Queensland Floods Commission of Inquiry

**Brisbane River 2011 Flood Event –
Flood Frequency Analysis
Final Report by WMAwater
September 2011**

**Expert Comments by
Erwin Weinmann**

October 2011

Figure 1 Comparison of annual peak flow data 1890-2011 (pre-dam conditions, flood peaks above threshold of 2000 m³/s)

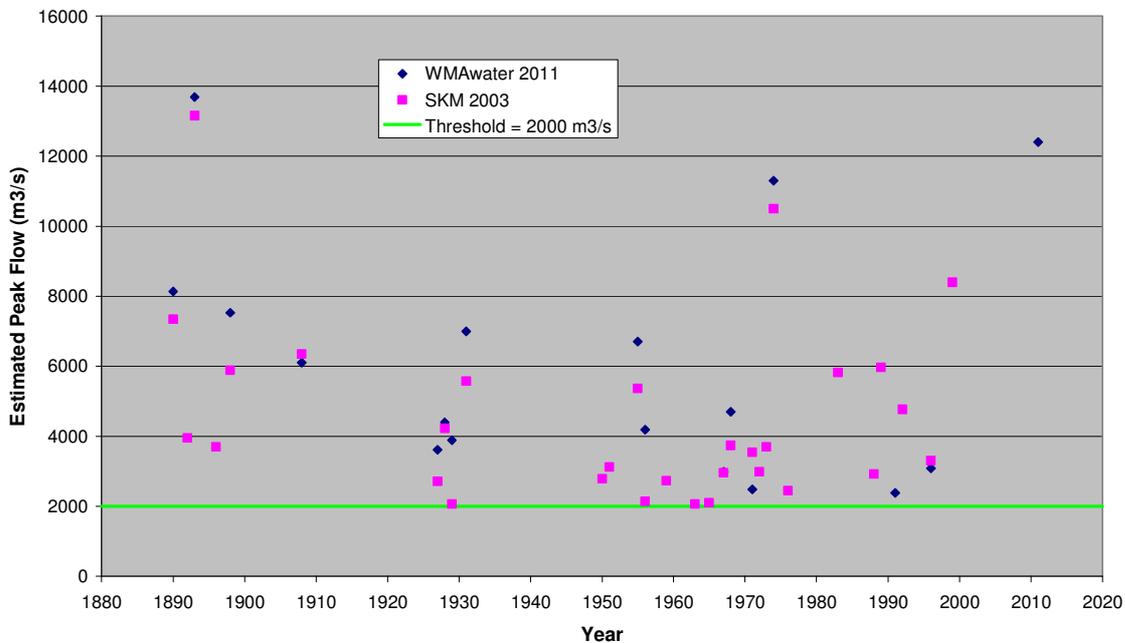
Figure 1 below shows a comparison of the pre-dam peakflow estimates for the Port Office site (as used in WMA 2011) and the values used by SKM (2003) for the Savages Crossing site (including simulated peak flows for the events that occurred after construction of the two Dams).

The comparison indicates that the estimates for the largest flood events ($> 5000 \text{ m}^3/\text{s}$) are within about 10 to 20% of each other and thus quite consistent, given the likely influence of a range of factors that introduce variations in flood peaks between the two sites. However, the WMA (2011) pre-dam peak flow series misses some significant flood events which have occurred since the construction of Wivenhoe Dam and have been substantially mitigated by the dam (notably the 1999 event).

It would be highly desirable for any future detailed flood study to use the available flood data from all four sites in accordance with their special merits and limitations. This would allow some checking of flood estimates for consistency and would help to reduce the remaining uncertainty in design flood estimates.

Figure 2 Conceptual diagram illustrating the possible and plausible ranges of flood peak attenuation by Somerset and Wivenhoe Dams

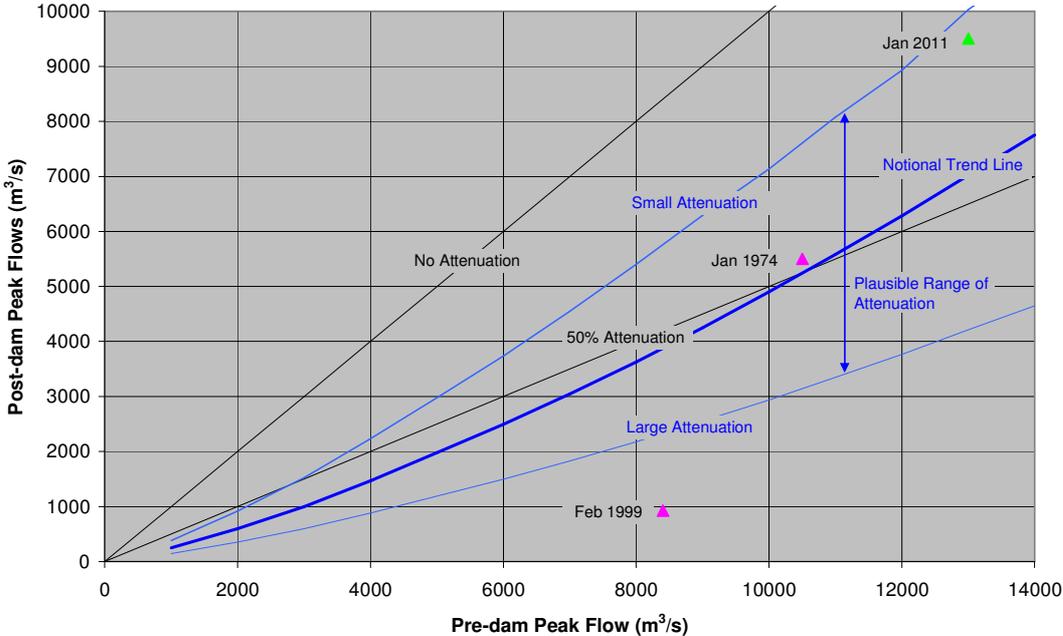
Figure 2 gives a qualitative indication firstly of the *possible range of attenuation* by the two dams, from no attenuation when a flood is generated essentially in the parts of the catchment below Wivenhoe Dam, to virtually full attenuation when the flood is generated in the parts of the catchment above Wivenhoe Dam and when there is a large storage volume available relative to the flood volume. Secondly the figure shows a narrower *plausible range of attenuation within which most of the flood events could be expected to fall*.

The January 2011 flood appears to lie near the upper end of the plausible spectrum of variation, where the special characteristics of this event resulted in only a modest degree of attenuation. At the other end of the spectrum is the February 1999 flood, which resulted in a substantial inflow to the dams (Appendix D of SKM 2003 shows a simulated pre-dam flood peak flow of 8400 m³/s at Savages Crossing) but there was only a minor flood recorded below the Dam. The estimated attenuation associated with the January 1974 event lies near the middle of the spectrum².

The methodology used in the WMA (2011) report to estimate the post-dam 1% AEP peak flow at the Port Office is based on very few data points which do not properly account for the large degree of variability and estimation uncertainty introduced by variations in storm characteristics and initial catchment/storage conditions. Use of the estimated attenuation effect for the January 2011 flood event as the main basis for determining the post-dam 1%AEP peak flow and corresponding flood level profile is considered to be arbitrary and likely to lead to biased flood estimates. Without confirmation from further analysis, the WMA

(2011) peak flow estimate of 9500 m³/s can therefore not be considered to represent a 'best estimate' of the 1% AEP peak flow for the lower Brisbane River under post-dam conditions.

In my opinion a proper assessment of the likely attenuation effects of the dams on design floods for the lower Brisbane River system needs to be based on simulation modelling studies that examine the effects of likely variations in the key flood producing and flood modifying factors identified in Table A1. The variability effects could be assessed in an approximate fashion by sensitivity analyses, but preferably in a more formal joint probability framework, using Monte Carlo simulation methods. Such an approach would also give a more quantitative indication of the uncertainty in the post-dam design flood estimates.
